# CITY OF ALBUQUERQUE

RE: Burger King

3221 Coors Blvd NW Grading and Drainage Plan Engineer's Stamp Date: 04/24/24 Hydrology File: G11D003D

Burger King (Coors Blvd) .dw SHEET# C1 ALBUQUERQUE, NM 87199 (505) 321-9099 JOB#

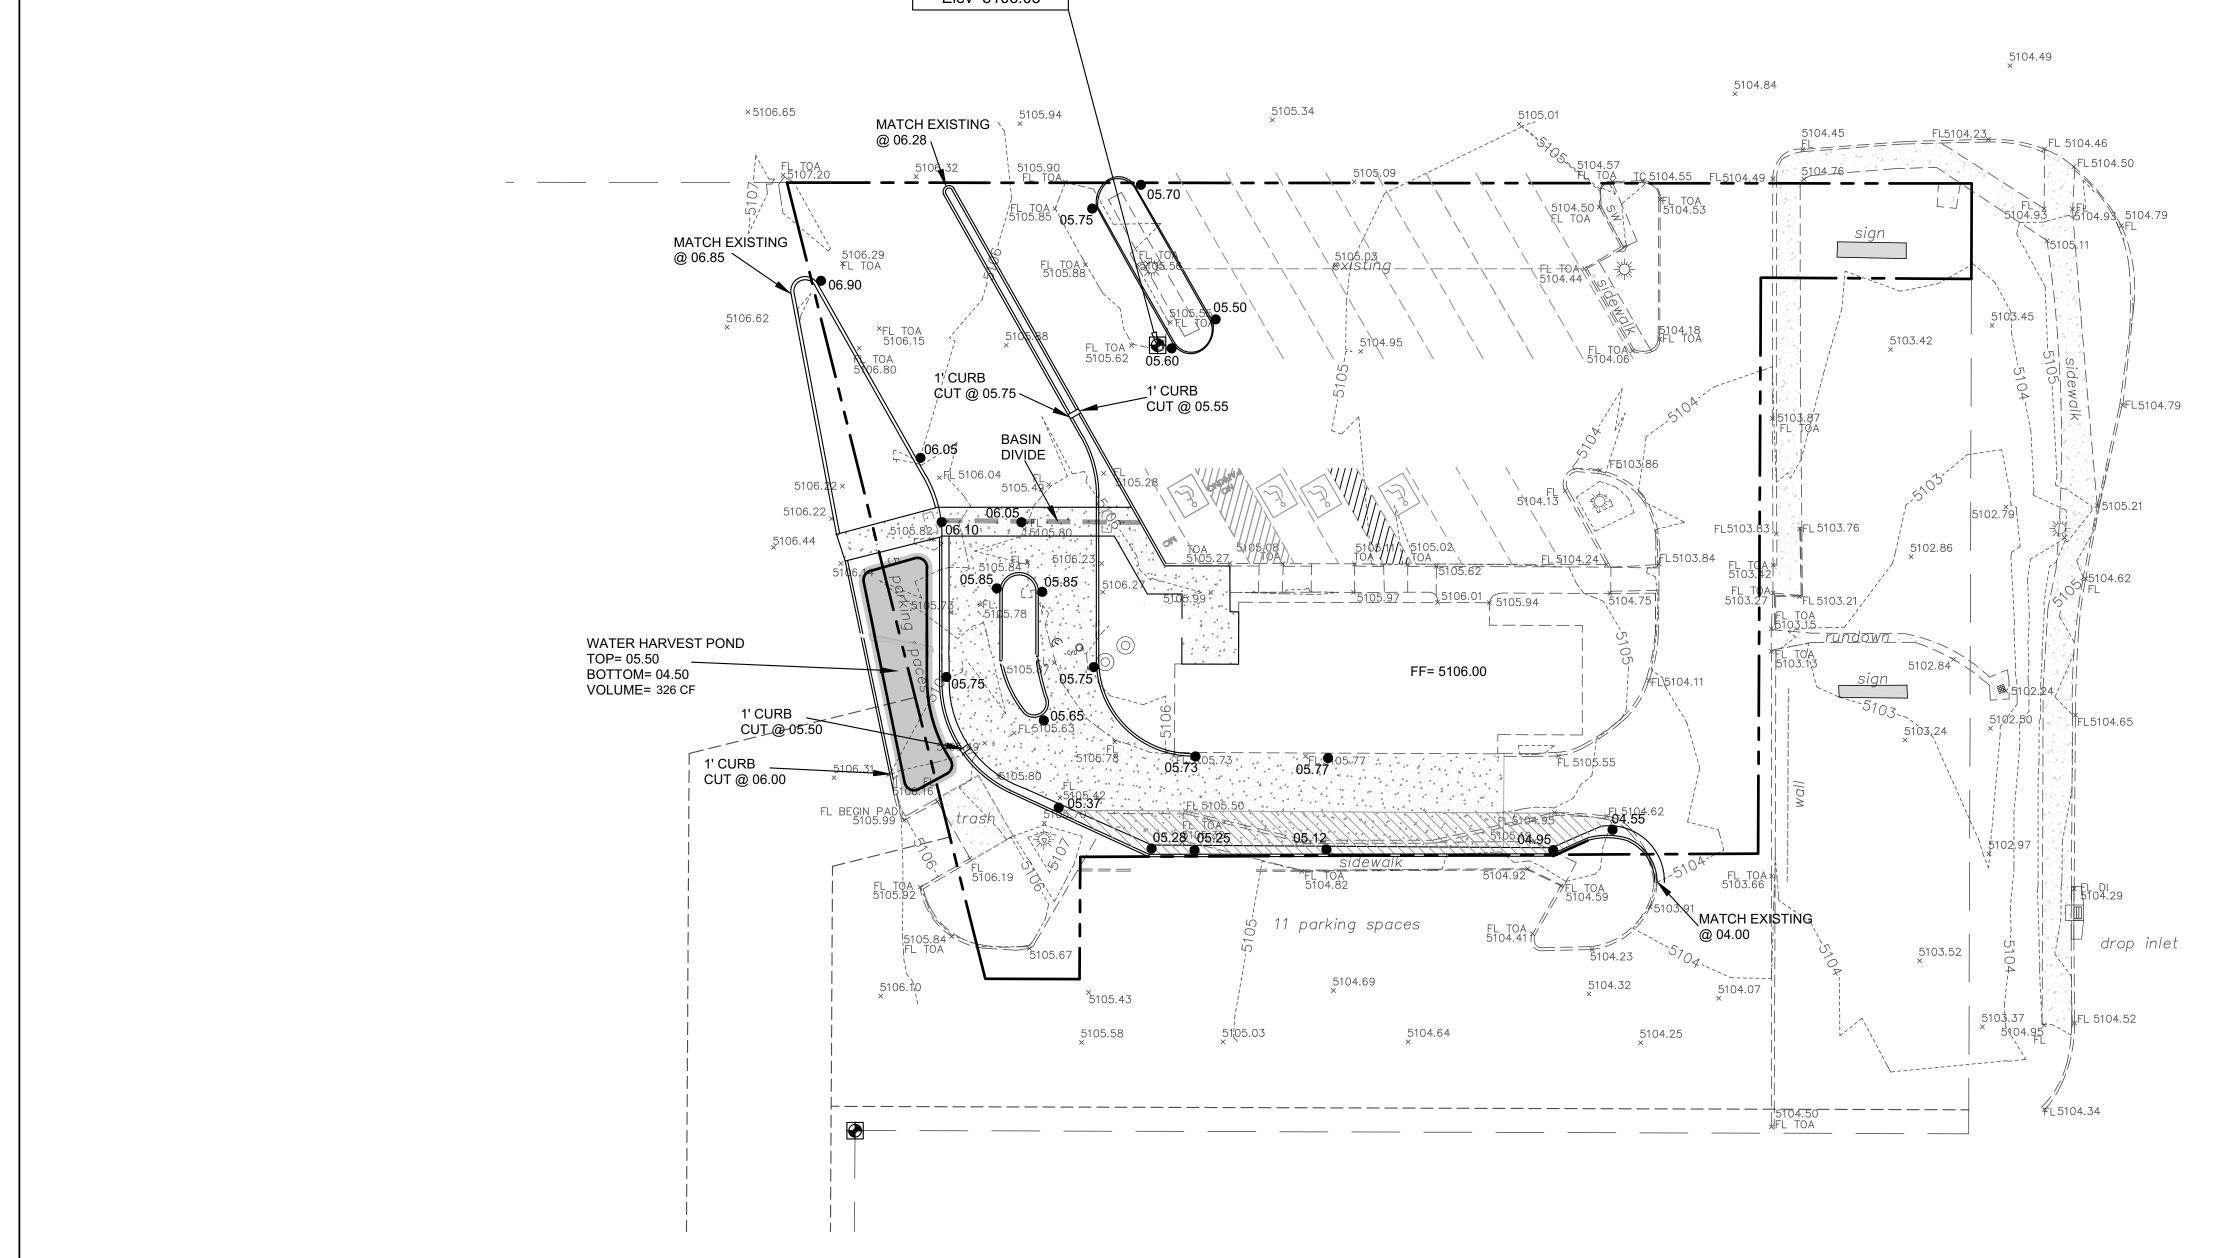
Based upon the information provided in your submittal received 04/25/2024, the Grading & Drainage Plan is approved for Paving Permit and Grading Permit. Please attach a copy of this approved plan in the construction sets for Paving Permit processing along with a copy of this letter. Once the grading and paving of the project is complete, please provide an as-built for Hydrology's records.

1. At your earliest convince, please provide the executed paper Drainage Covenant (latest revision) printed on one-side only with Exhibit A and a check for \$25.00 made out to "Bernalillo County" for the stormwater quality pond per Article 6-15(C) of the DPM to Hydrology for review at Plaza de Sol.
